Kathlyn Oliver House, 248-250 Camden Road

Questions & Answers

December 2025 (updates since November in green)

1.3a

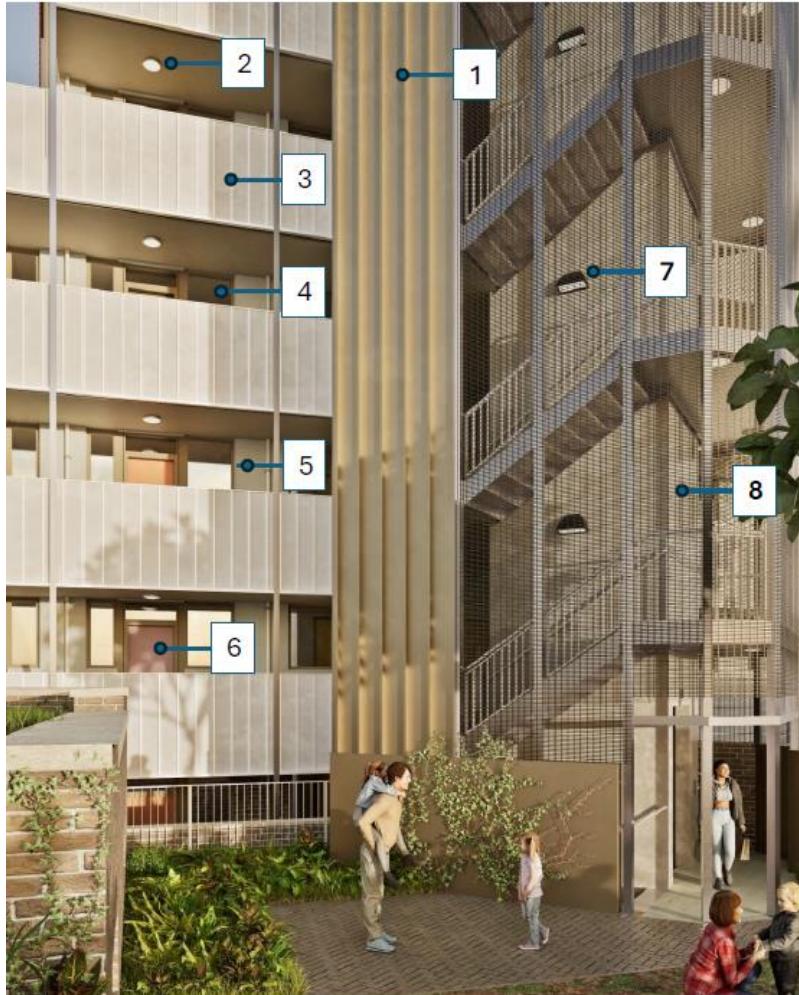
Appendix 1.3 includes two model screenshots, one taken from behind the community room and another from the garden area near the W/C unit. Please note that the existing tree is not shown in the model, so the second image does not reflect how the tree will naturally help to screen part of this view. The section screenshot is taken from the growing garden area.
